**PRELIMINARY/FINAL DRAINAGE REPORT**

**MIDTOWN COLLECTION AT HANNAH RIDGE  
FILING No. 3**

**(A Replat of Tract CC, Hannah Ridge at  
Feathergrass Subdivision Filing No. 1)**

**DECEMBER 2021**

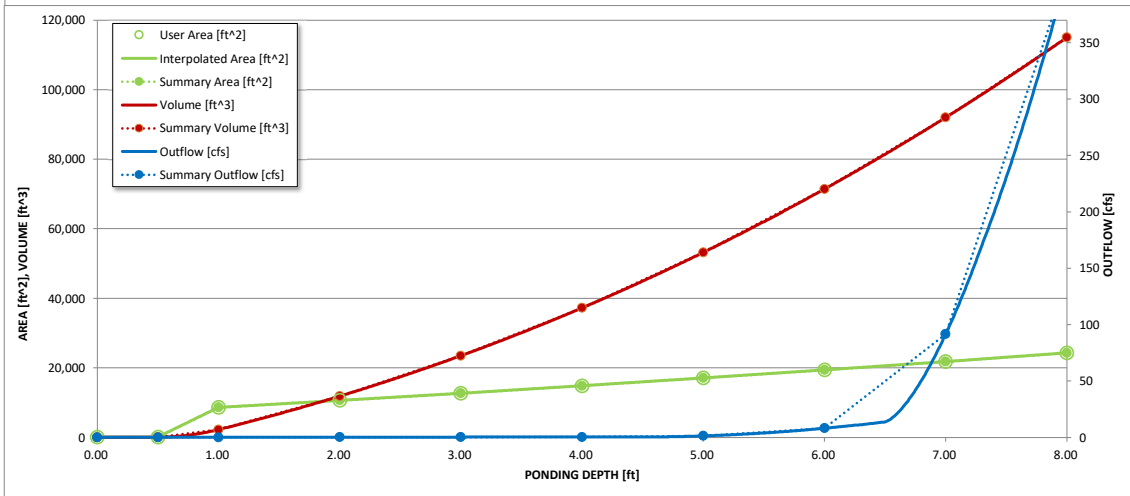
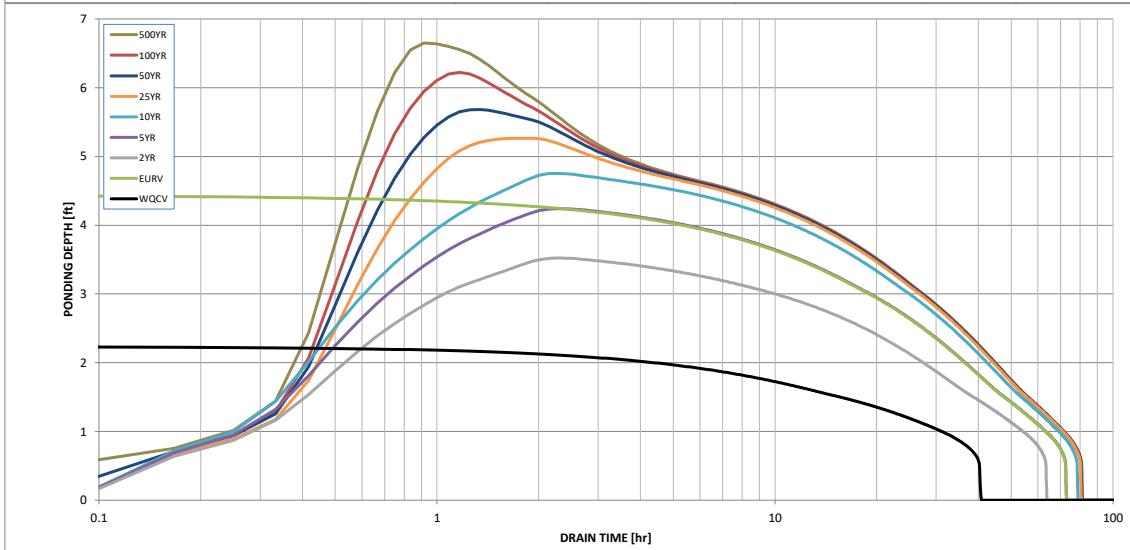
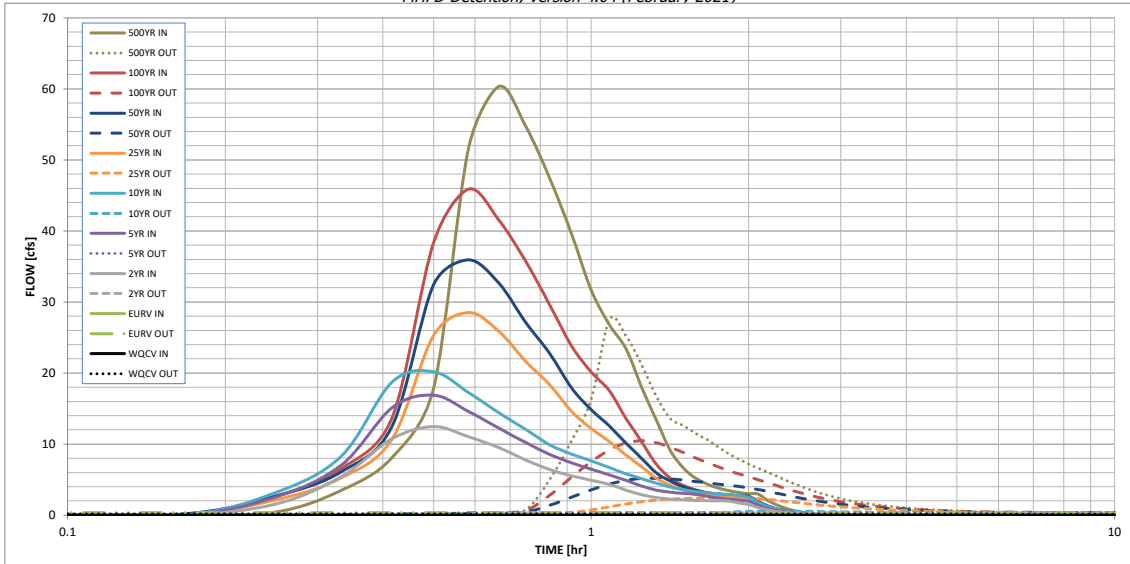
just leave this blank, otherwise it implies that a restrictor plate will be installed above the pipe for future use.

**EMERGENCY SPILLWAY CROSS SECTION B-B**  
SCALE: N.T.S.

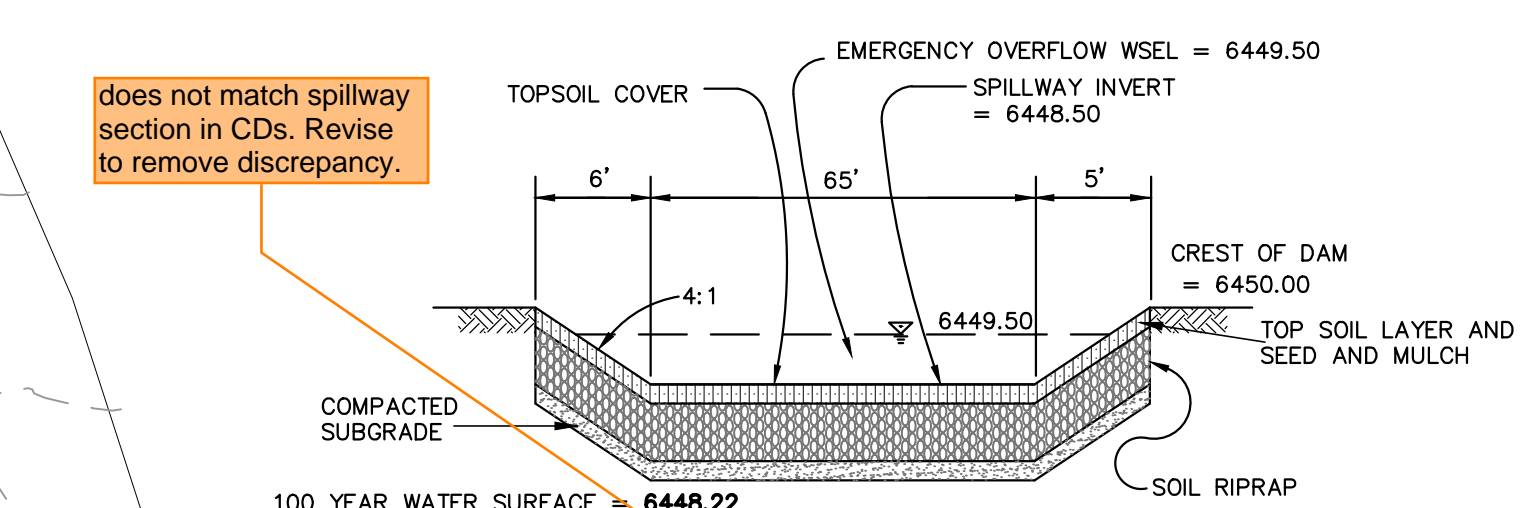
does not match spillway section in CDs. Revise to remove discrepancy.

MIDTOWN COLLECTION AT HANNAH RIDGE			
FILING NO. 3			
DEVELOPED CONDITIONS DRAINAGE MAP			
DESIGNED BY	KRC	SCALE	DATE 03/17/22
DRAWN BY	KC	(H) 1" = 40'	SHEET 1 OF 1
CHECKED BY	KRC	(V) 1" = N/A	JOB NO. 1116.35

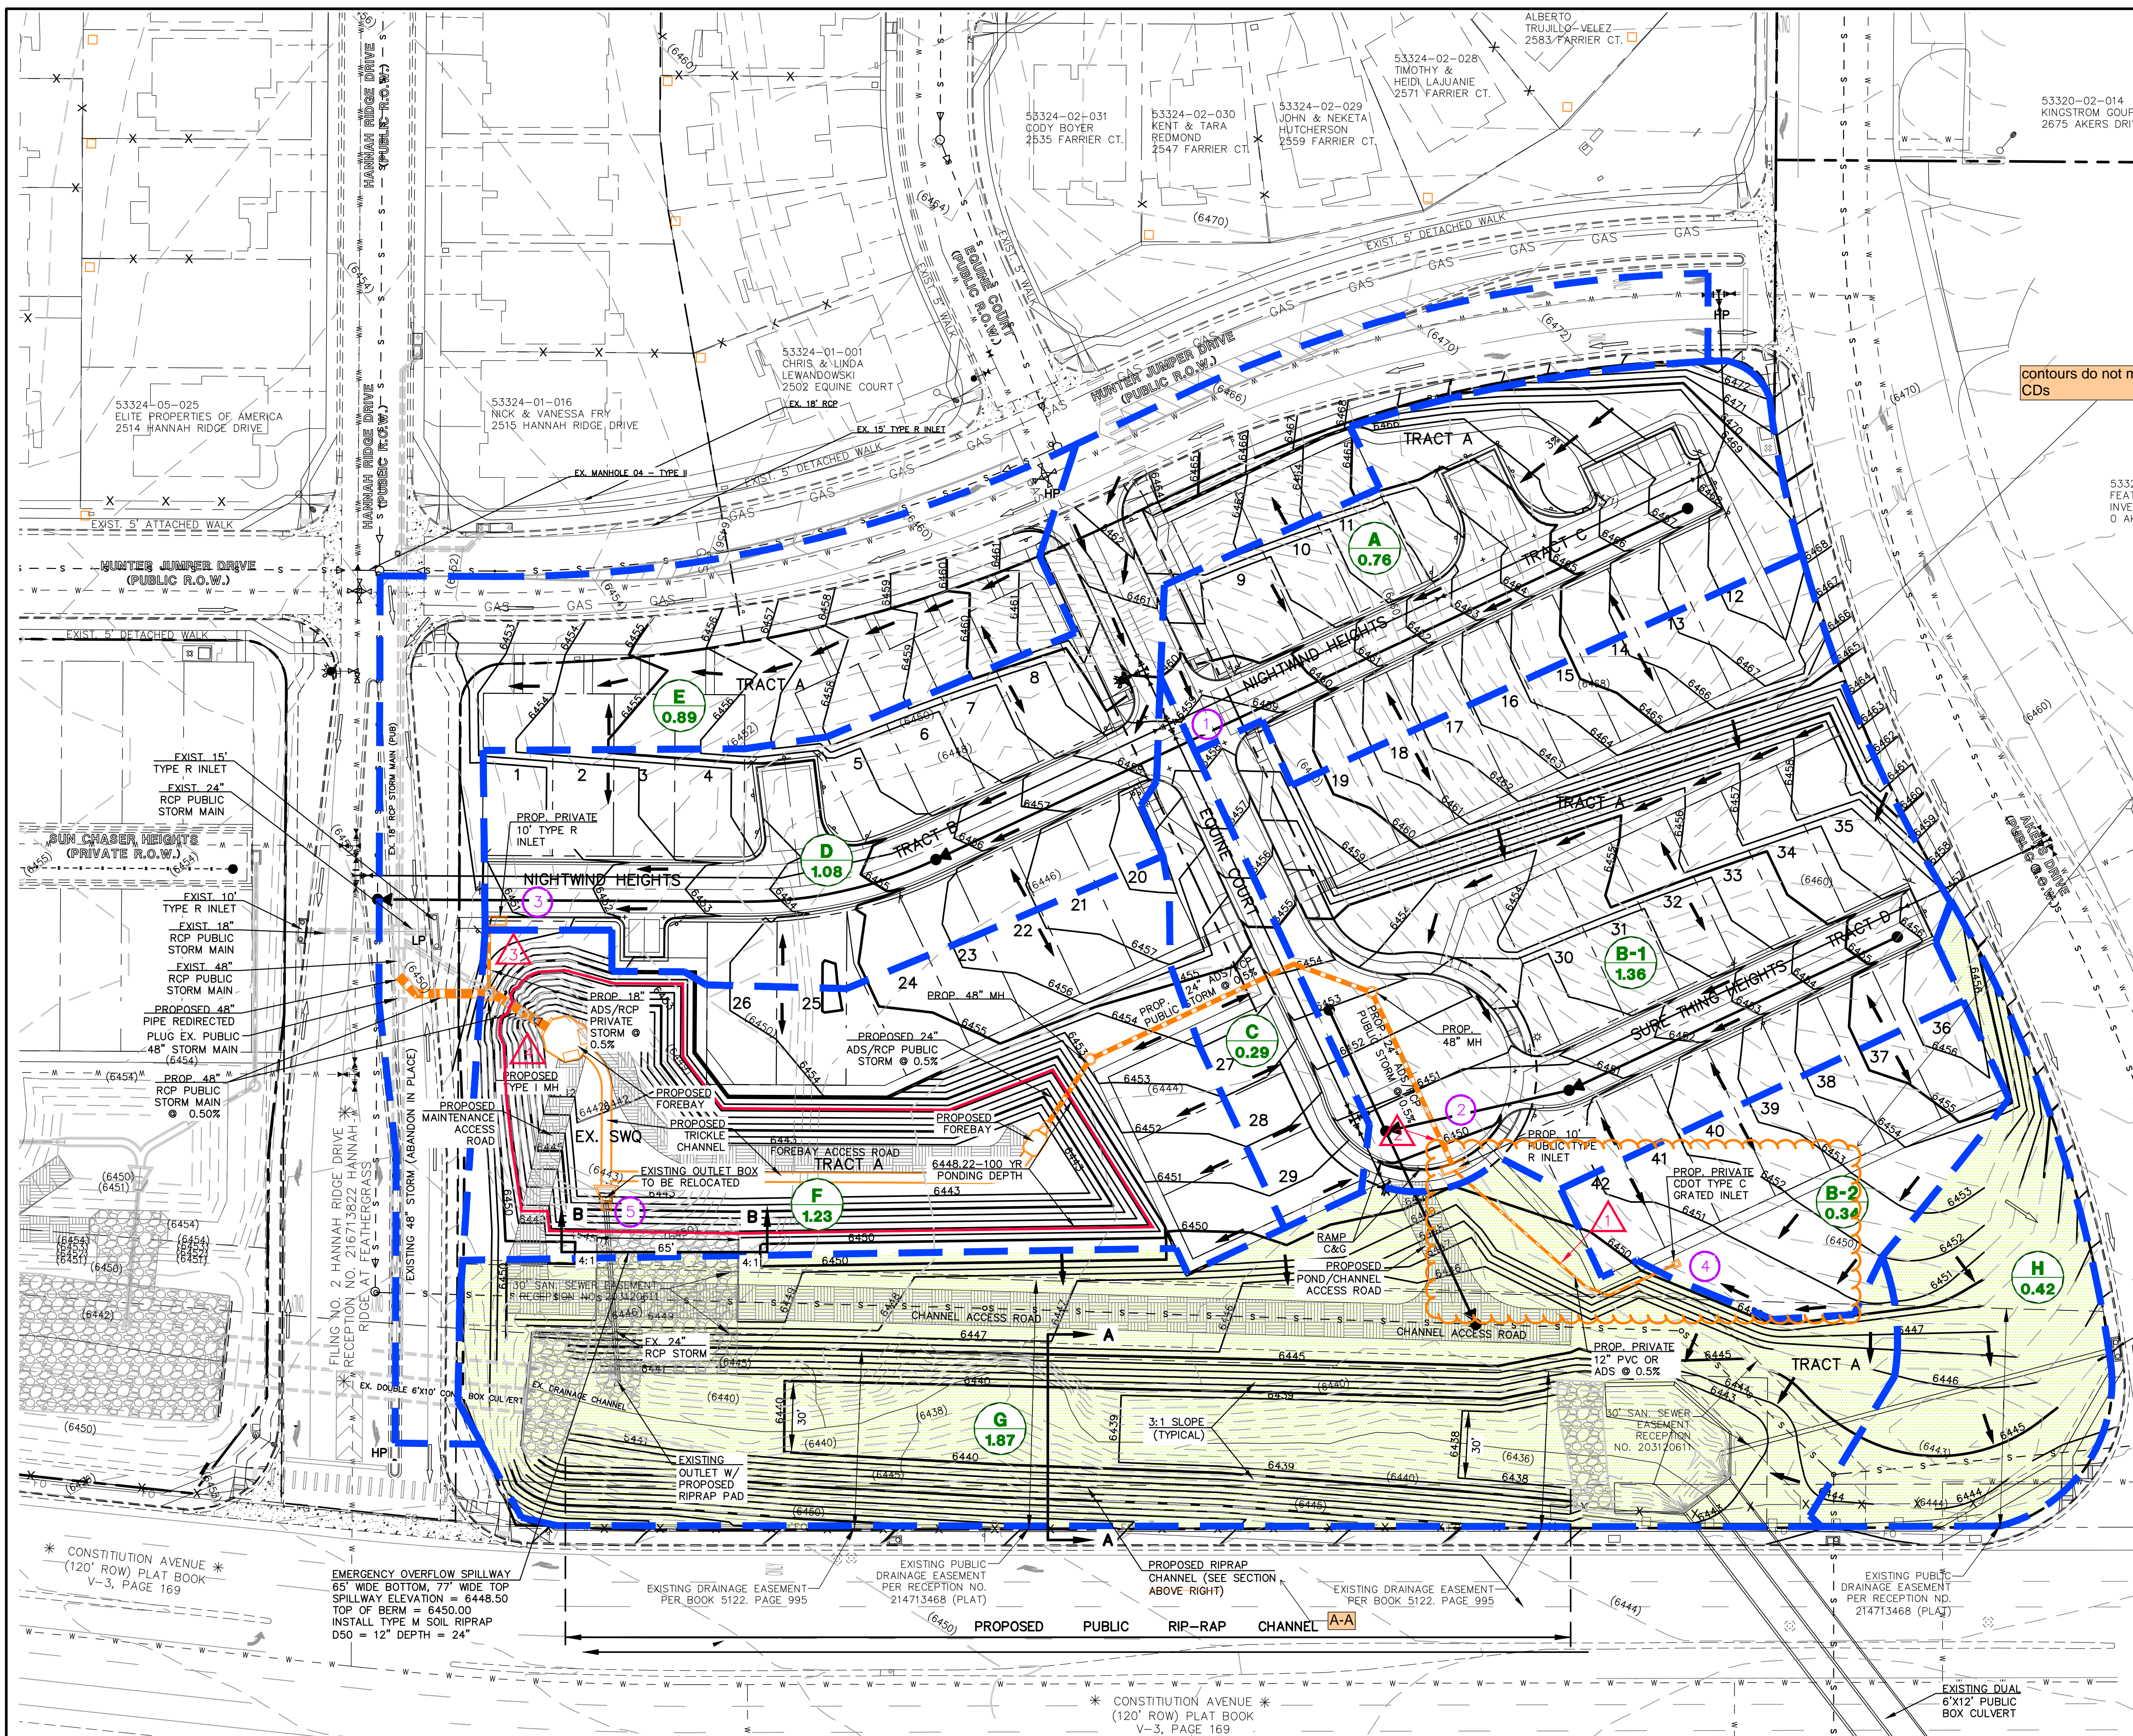
We need to know how much of the proposed area of disturbance (not just the impervious surfaces) is treated vs untreated and if there are any exclusions that apply to the untreated areas. So please create a basic overview map (or modify an existing drainage map) with color shading/hatching that shows areas tributary to each PBMP (pond, runoff reduction, etc.) and those disturbed areas that are not treated by a PBMP, with the applicable exclusion labeled (ex: 20% up to 1 ac of development can be excluded per ECM App I.7.1.C.1 (only if using the WOCV/Design Base Standard) and exclusions listed in ECM App I.7.1.B.#). An accompanying summary table on this map would also be very helpful (example provided).

Basin H & G are two different WQ exclusions.  
 change hatching and note exclusion used for each.
